Application Number: 10/718,086
Filing Date: November 19, 2003
Appellant(s): CLEMENS, READE

EXAMINER'S ANSWER

FIG. 2

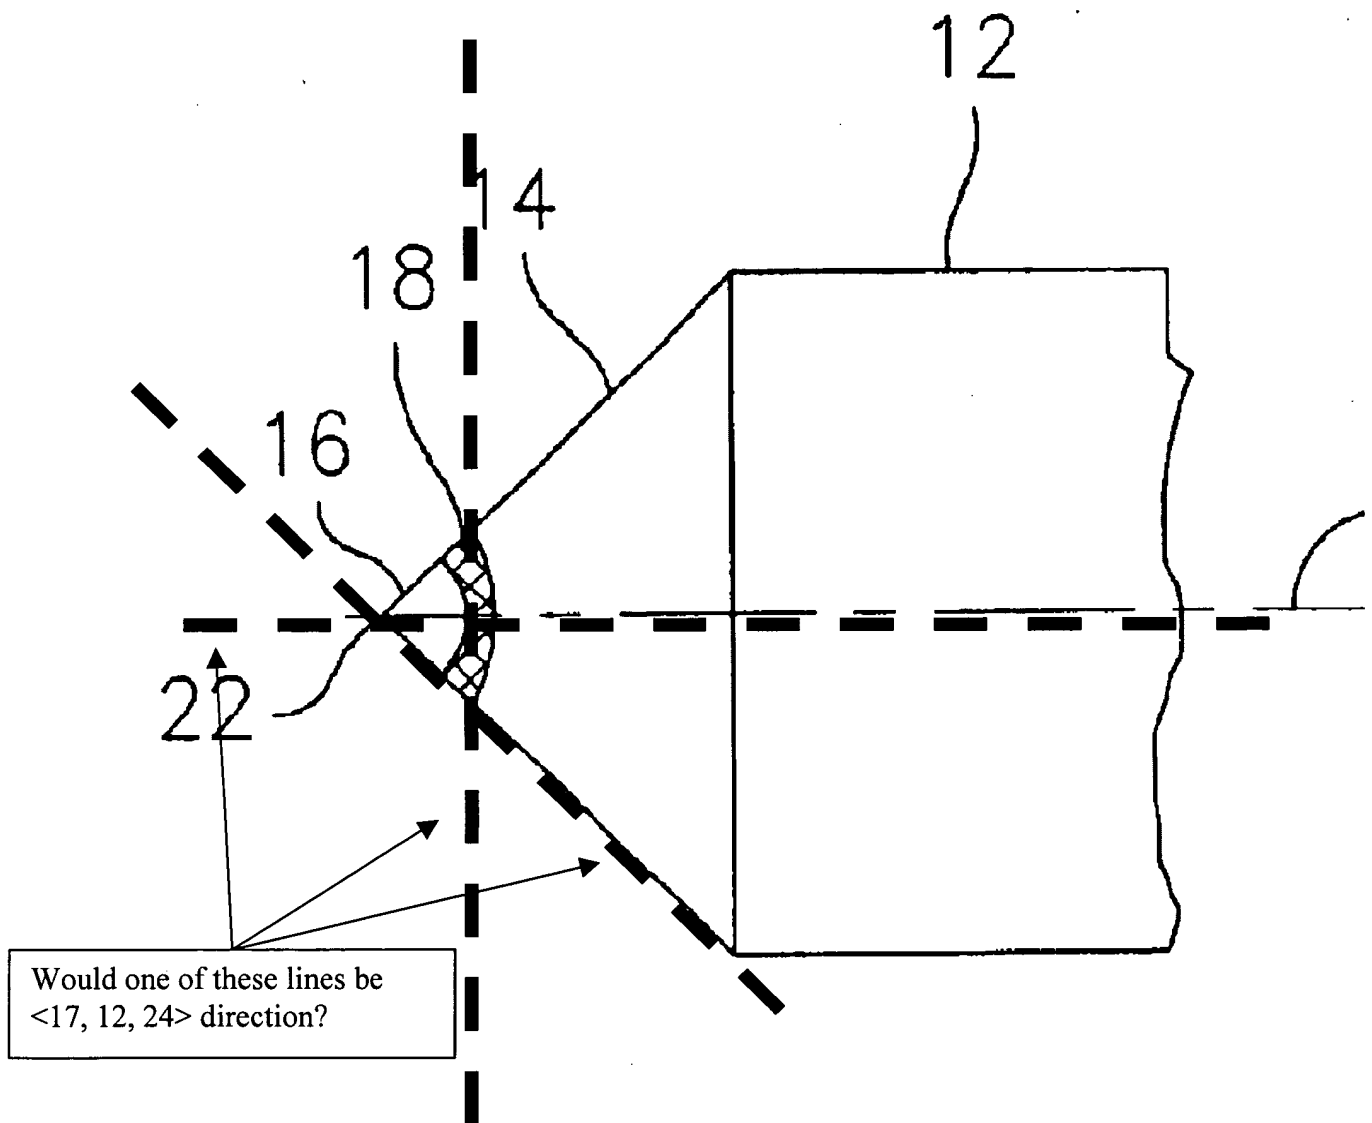
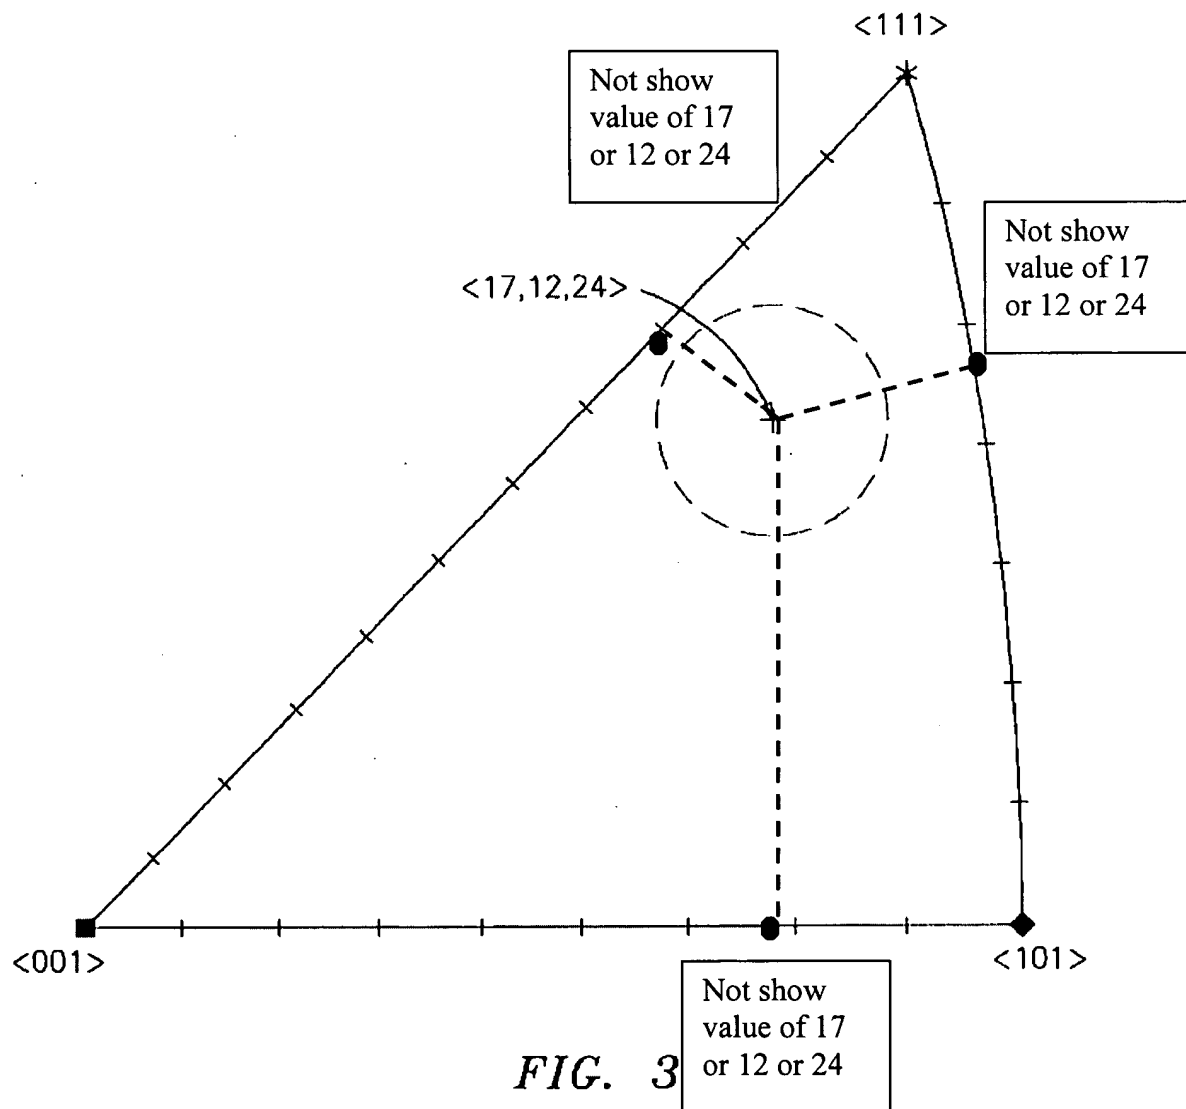
The Applicant does not provide enough information of the <17, 12, 24> direction so that one of ordinary skill in the art can make and use the claimed invention. For example, would the

cutting tip 22 in Fig. 1 of the disclosure not be tilted more than 8 degrees with respect to the shank axis 24 is what the Applicant claims? Or would one of the surfaces of the indenting tip be <17, 12, 24> direction? See below sketch.

The Applicant asserts that Fig. 3 represents the $\langle 17, 12, 24 \rangle$ direction. However, projecting perpendicular lines from the coordinate $\langle 17, 12, 24 \rangle$ does not produce the same value of the coordinate. See below sketch.

FIG. 8

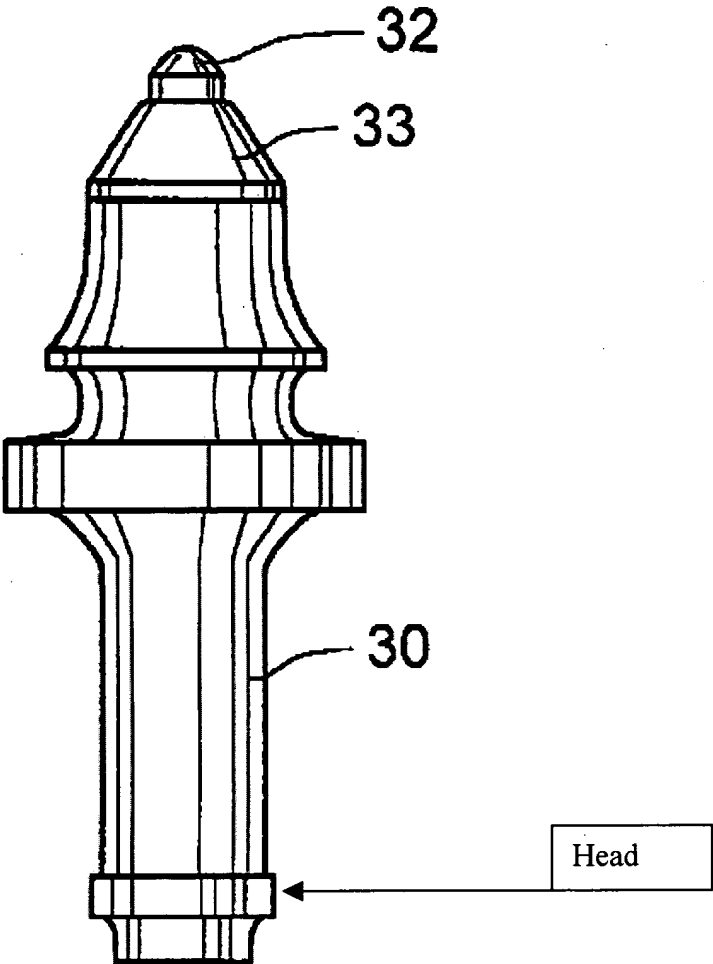
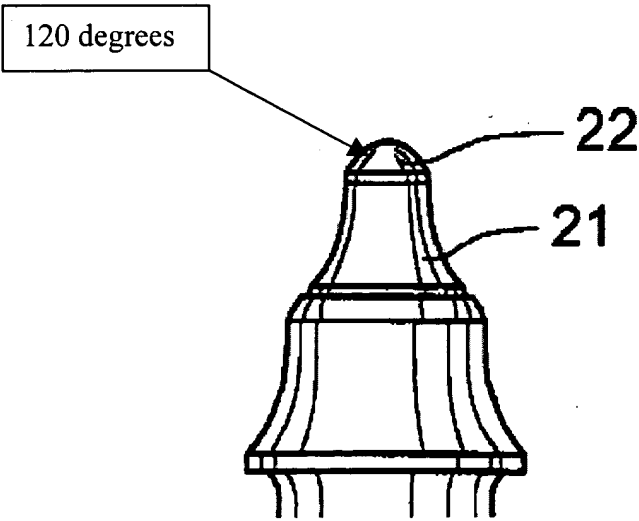
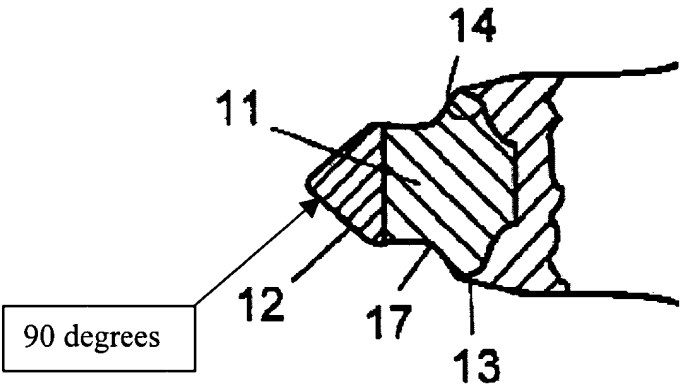
The Applicant argues that Anderson does not teach forming a shank to which a diamond is attached from steel (claim 2); a head formed adjacent a second end of the shank (claim 3); a head which is wider than the shank (claim 4); the use of a single crystal diamond (claims 5 and 6); a diamond which in a final ground state has a length greater than an indentation depth to be imparted to a part to be marked (claim 8); a diamond having a 90 degree included angle conical point (see Fig. 7); a diamond having a 120 degree included angle conical point (see Fig. 5); a brazing alloy which wets both the diamond and the material forming the shank (claim 11); and a shank with a tapered tip end (claim 12) to which a diamond is attached. This argument is not persuasive.

Anderson teaches forming a shank to which a diamond is attached from steel (col. 5, lines 5-10); a head formed adjacent a second end of the shank (see Fig. 8); a head which is wider than the shank (see Fig. 8); the use of a single crystal diamond (there is one indenting tip and it is covered by diamond coating; therefore the indenting tip is a single diamond); a diamond which in a final ground state has a length greater than an indentation depth to be imparted to a part to be marked (it is inherent.); a diamond having a 90 degree included angle conical point (see Fig. 3); a diamond having a 120 degree included angle conical point (claim 10); a brazing alloy which wets both the diamond and the material forming the shank (see the Abstract and col. 3, lines 29-54); and a shank with a tapered tip end 12 (see Fig. 3) to which a diamond is attached.
